Approval of Dulles PE Refinement Public Hearing Staff Report and Authorization for GM to Execute Agreement with Metropolitan Washington Airports Authority (MWAA) for Design-Build Support Services

**Washington Metropolitan Area Transportation Authority  
Board Action/Information Summary**

**Dulles Corridor Metrorail Project  
Preliminary Engineering  
Refinements and Authority for  
General Manager to Execute an  
Agreement with Metropolitan  
Washington Airports Authority**

PE DESIGN REFINEMENTS  
DULLES CORRIDOR METRORAIL PROJECT  
VIRGINIA

# PE Design Refinements

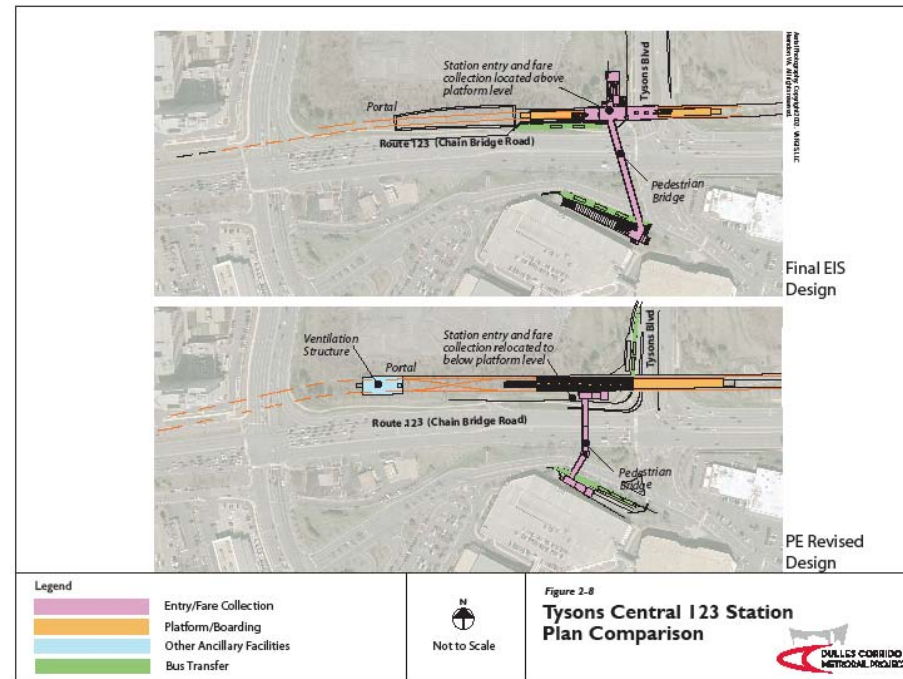
- Requirements:
  1. Redundant Elevators at pedestrian bridge entrances
  2. West Falls Church Maintenance Shop Expansion
  3. Stormwater management facility west of Hunter Mill Road

-The project team recommends retention of redundant elevators at the pedestrian bridge entrances. Although DRPT had proposed removal of elevators, this refinement was withdrawn. Redundant elevators will promote greater system reliability.

-The project team recommends retention of the West Falls Church maintenance shop expansion and the associated modifications to the West Falls Church Yard. At the initiation of the EA, it appeared that adequate maintenance capability would exist within the WMATA system. Now, it appears that capacity will not be available, and consequently, the previously-planned expansion is required.

-The project team recommends retention of the stormwater management facility west of Hunter Mill Road. At the initiation of the EA, it appeared that adequate stormwater management capability would exist for this section of the alignment. Now, it appears

# PE Design Refinements

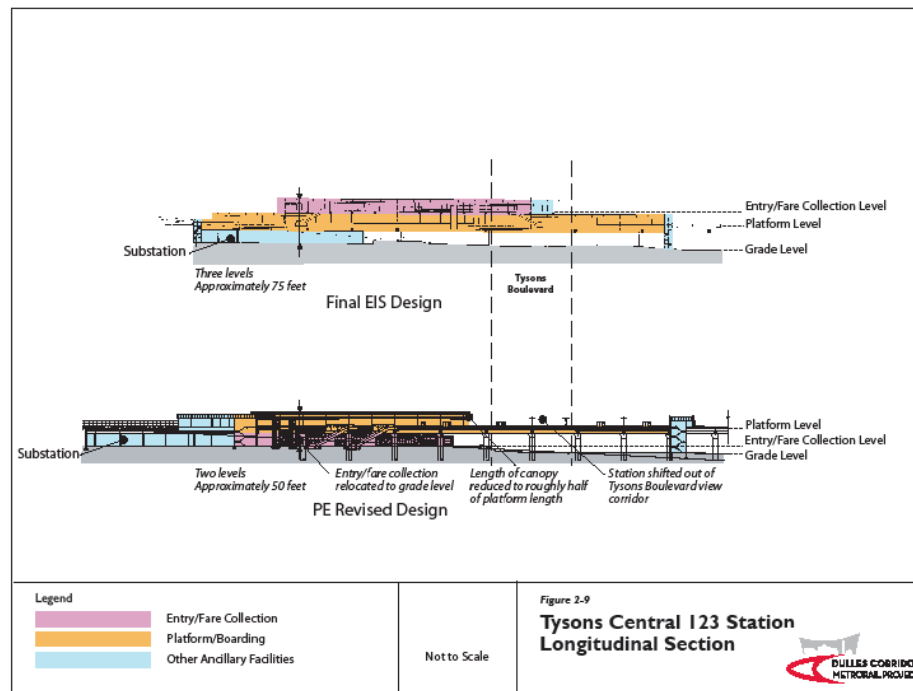
- **Conditionally Acceptable Refinements:**
  1. Reduction of the platform canopy length from 600 feet to 300 feet, assuming appropriate engineering.

-The project team concurs with reduction of the platform canopy length from 600 feet to 300 feet, assuming appropriate engineering controls are installed, including sufficient foundations for a future extension of the canopy to 600 feet total length, adoption of high friction paver tiles, and an engineering mechanism to heat the tile surface to minimize the buildup of ice and snow.

# PE Design Refinements

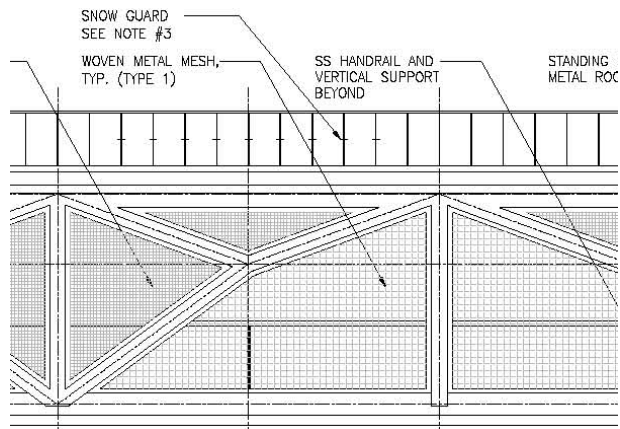
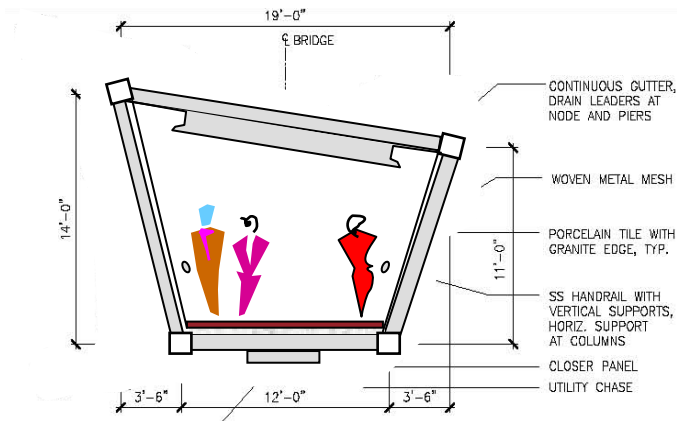
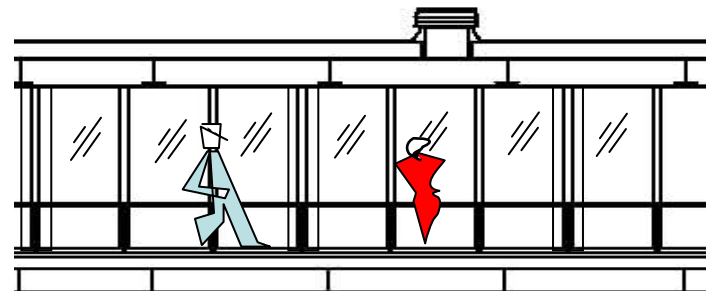
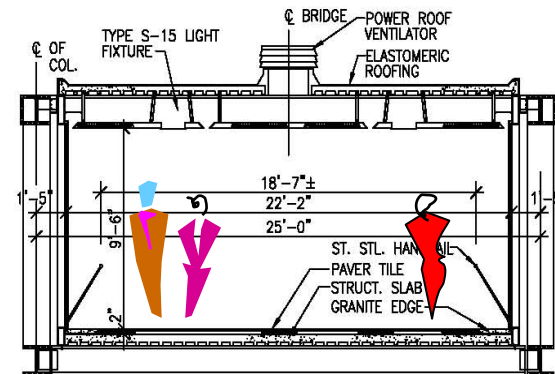
- **Conditionally Acceptable Refinements:**
  2. Substitution of glazing with wire mesh on the pedestrian bridges, assuming appropriate engineering.

--The project team concurs with the replacement of glazing on the pedestrian bridges, assuming appropriate engineering controls are installed including adoption of high friction paver tiles and an engineering mechanism to heat the tile surface to minimize the buildup of ice and snow.

**Tysons Central 7 Station  
Plan Comparison**

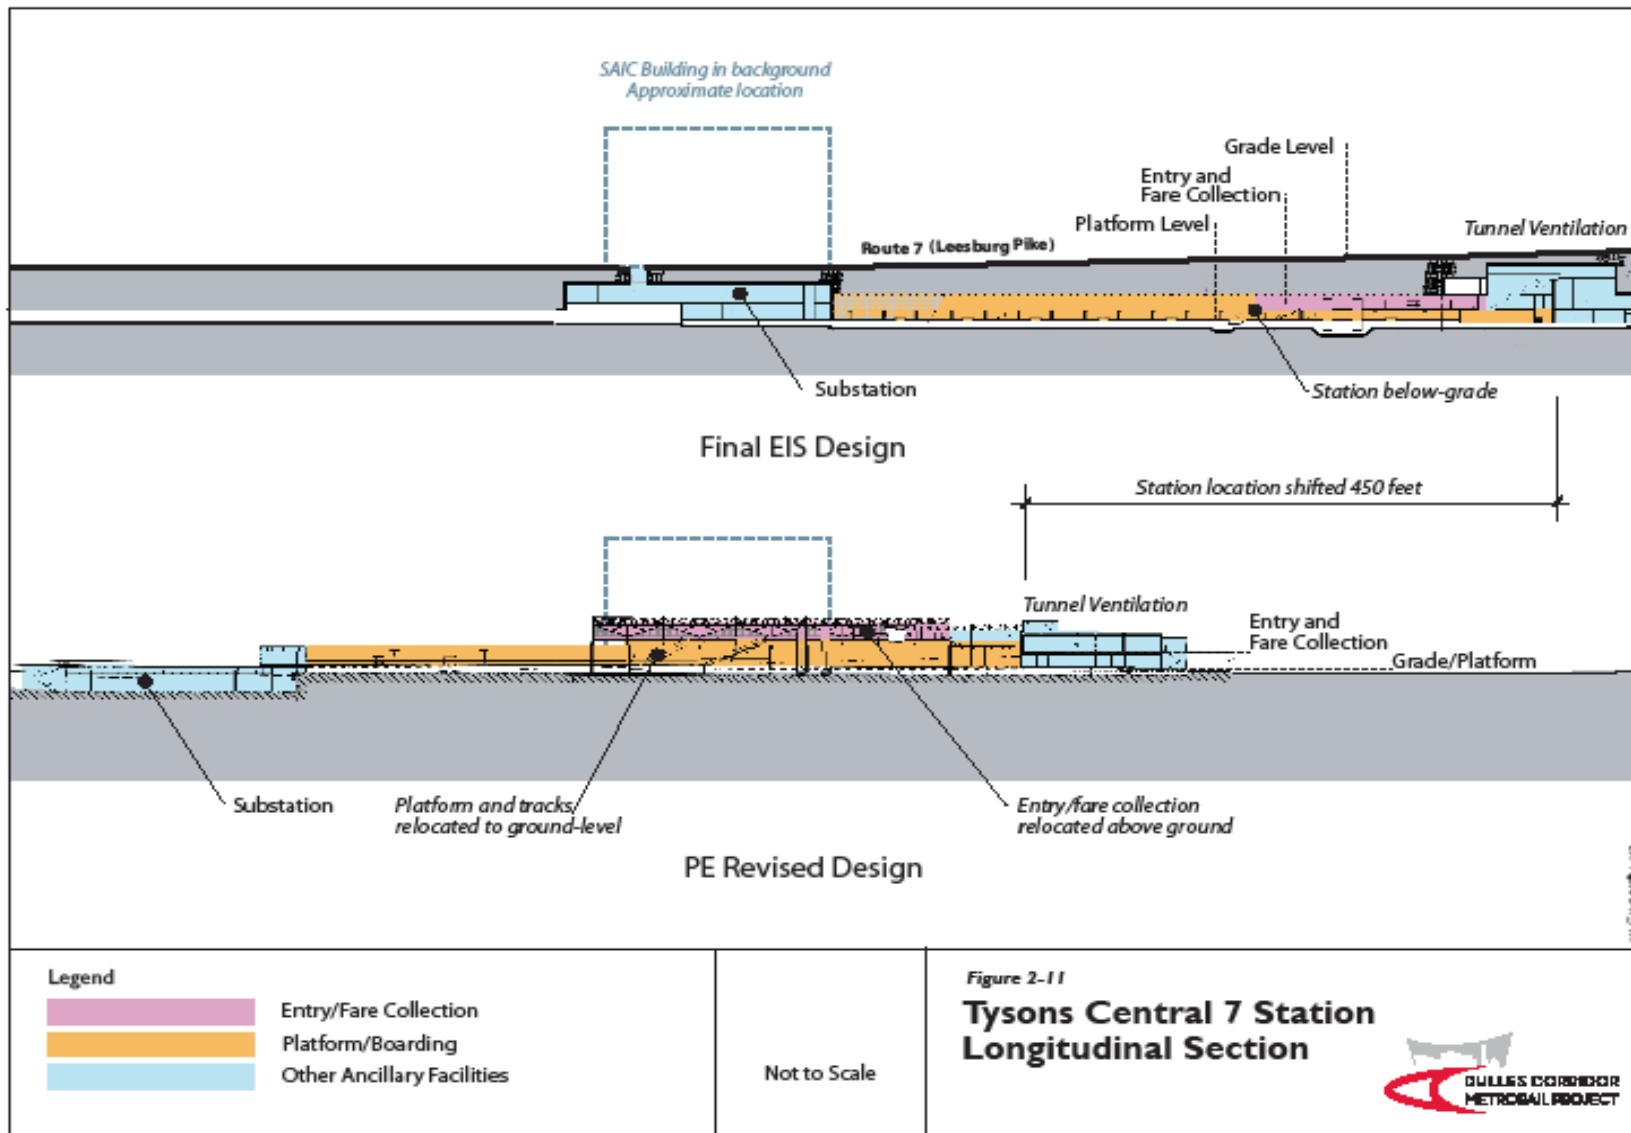
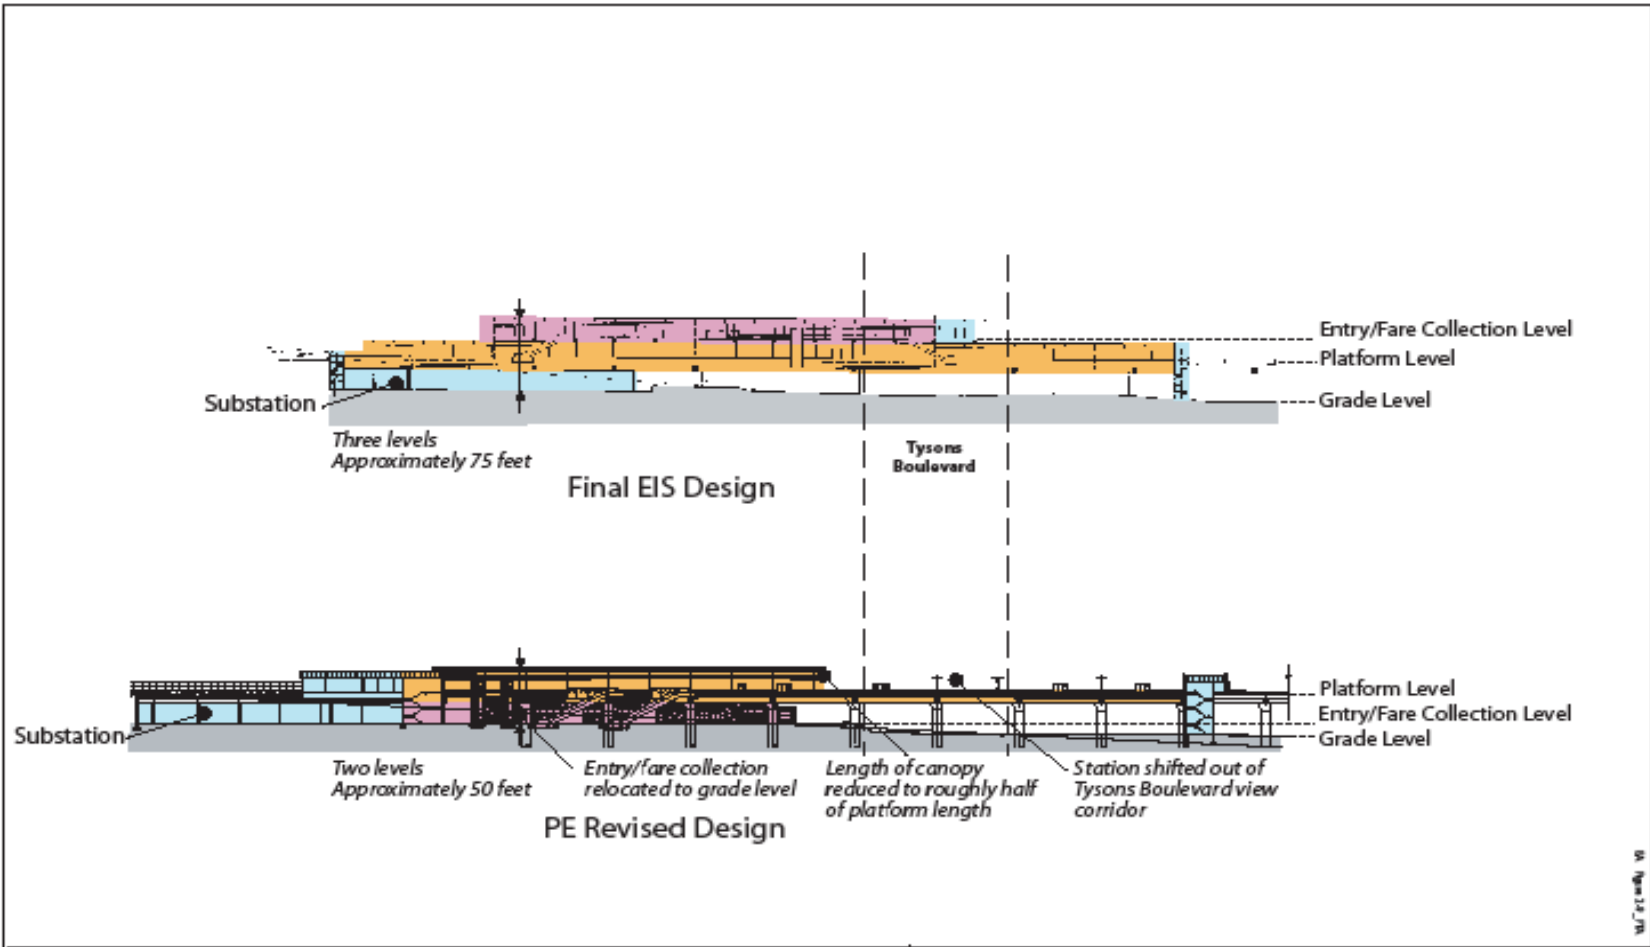
<b>(AL-6)</b>	Relocate double crossover from Tysons Central 7 station to Tysons Central 123	Refinement proposed for acceptance.
<b>TYSONS CENTRAL 7 STATION</b>		
<b>T7-1</b>	Replace the underground Tysons Central 7 station with an at-grade station in the median of Route 7 (no change to station entrance locations).	Refinement proposed for acceptance.
<b>T7-2</b>	Replace underground pedestrian walkways with pedestrian bridges.	Refinement proposed for acceptance.
<b>T7-3</b>	Eliminate underground station ventilation equipment.	Refinement proposed for acceptance.
<b>T7-4</b>	Redesigned station canopy with reduced coverage (300 feet long).	Proposed for acceptance pursuant to the DRPT letter of Nov. 2, 2006 (M. Tucker) which states that "The Dulles Corridor Metrorail Project currently has plans for canopy lengths of 600 feet ...[and] includes the new WMATA proposed "non-slip" square tile on the project."

Figure 2-8  
**Tysons Central I23 Station  
 Plan Comparison**

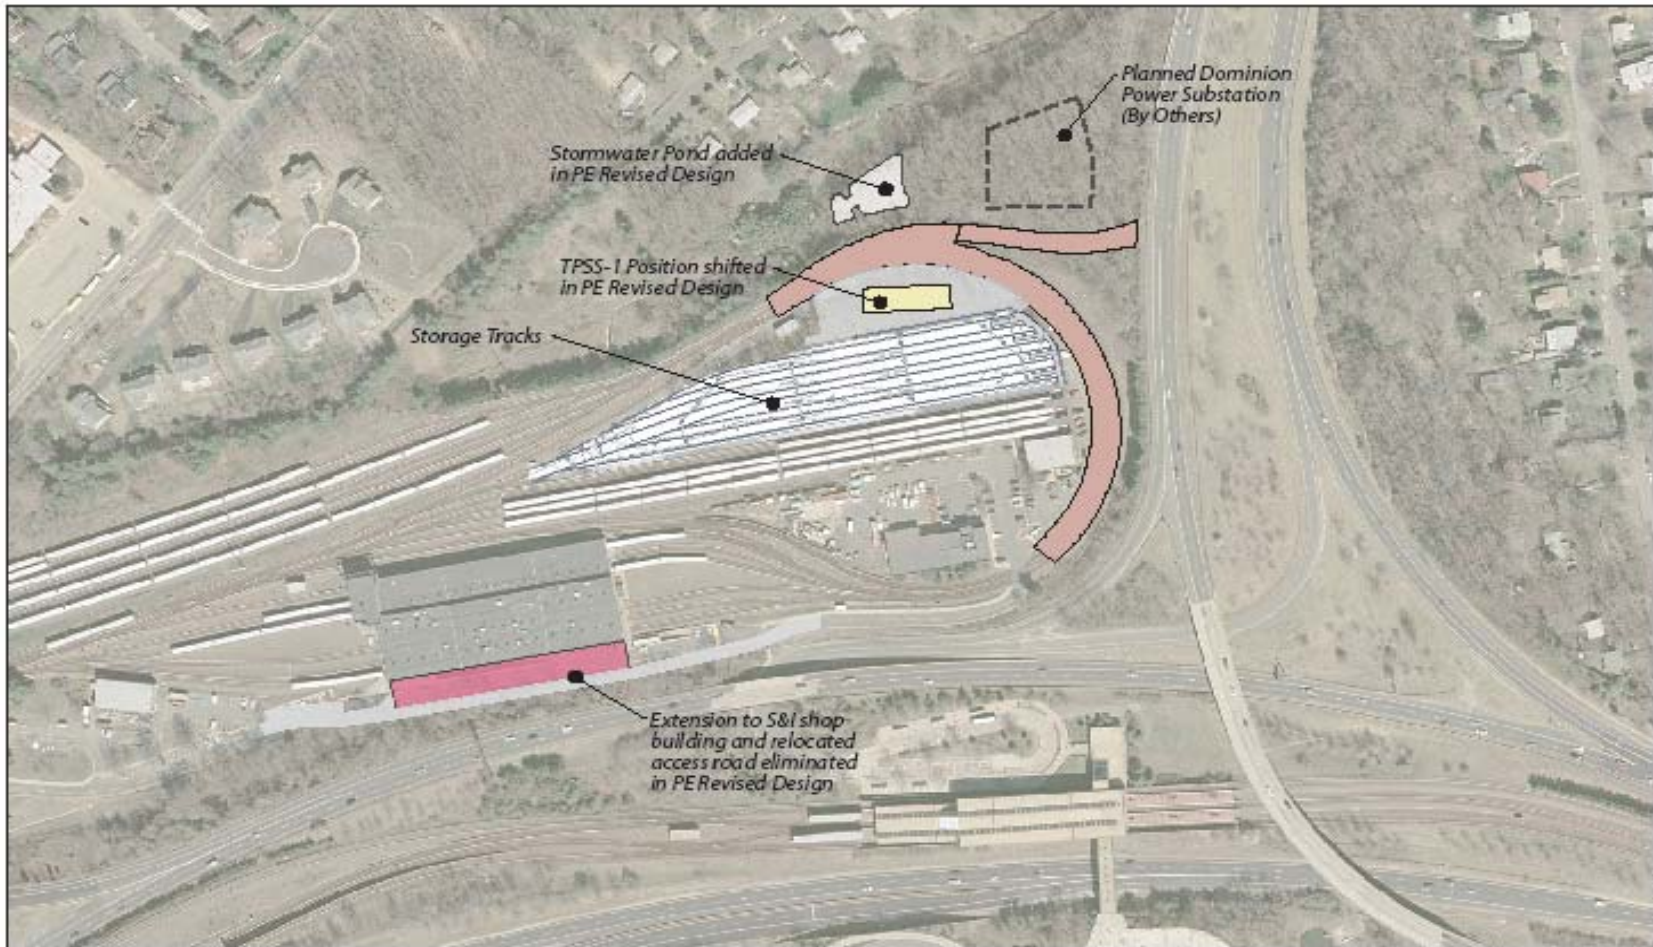
<b>TE-4</b>	Deletion of second elevator at south station entrance.	Refinement proposed for rejection.
<b>TYSONS CENTRAL 123 STATION</b>		
<b>TC-1</b>	Relocate mezzanine from elevated position above platform, to street-level location below the platform; pedestrian bridge decouple from mezzanine.	Refinement proposed for acceptance.
<b>TC-2</b>	Bus bays relocated from Route 123 to Tysons Boulevard.	Refinement proposed for acceptance.
<b>TC-3</b>	Redesigned station canopy with reduced coverage (300 feet long).	Proposed for acceptance pursuant to the DRPT letter of Nov. 2, 2006 (M. Tucker) which states that "The Dulles Corridor Metrorail Project currently has plans for canopy lengths of 600 feet ...[and] includes the new WMATA proposed "non-slip" square tile on the project."
<b>TC-4</b>	Redesigned pedestrian bridge with reduced width (12 feet) and with mesh enclosure instead of glazing.	Proposed for acceptance pursuant to the DRPT letter of Nov. 2, 2006 (M. Tucker) which states: "The "Dulles Corridor Metrorail Project currently has plans for...pedestrian bridges with a width of 16 feet, handrail to handrail. Additionally, the Project Scope includes the new WMATA proposed "non-slip" square tiles on the project." It further assures WMATA that they will "...follow the provision for changes...to ensure the safe and efficient operations (sic) of this system."

Figure 2-16  
**Changes to West Falls Church  
 Rail Yard**

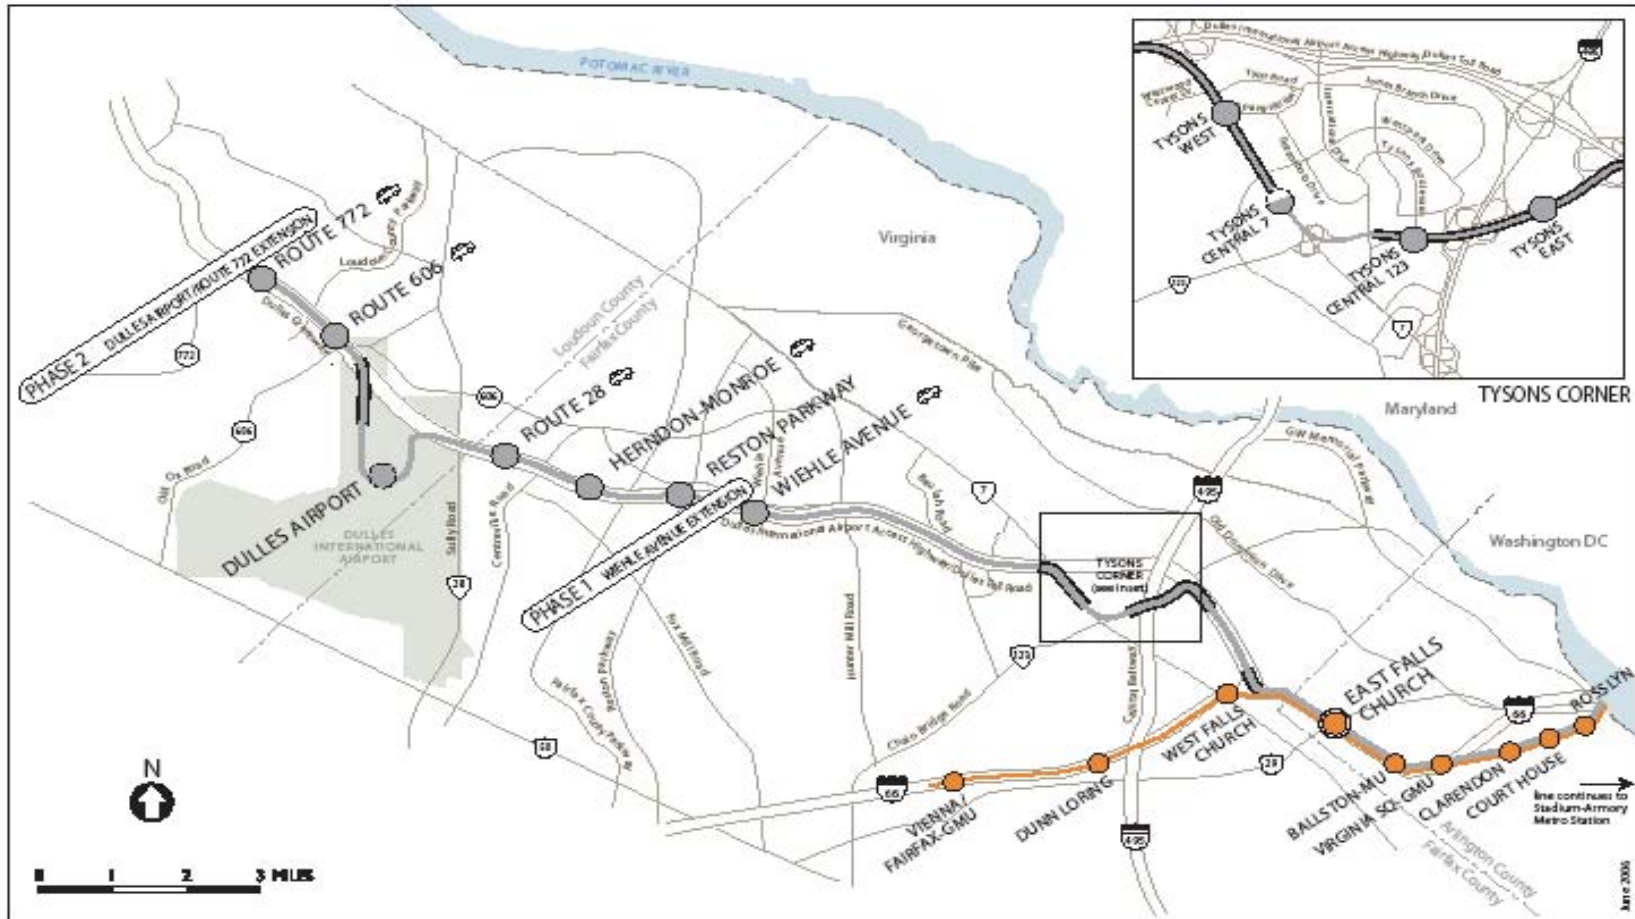
<b>WEST FALLS CHURCH YARD</b>		
<b>WFC-1</b>	Eliminate enlargement of the West Falls Church S&I Shop	Refinement proposed for rejection.
<b>WFC-2</b>	Construct a stormwater management pond at the West Falls Church Yard.	Refinement proposed for acceptance.
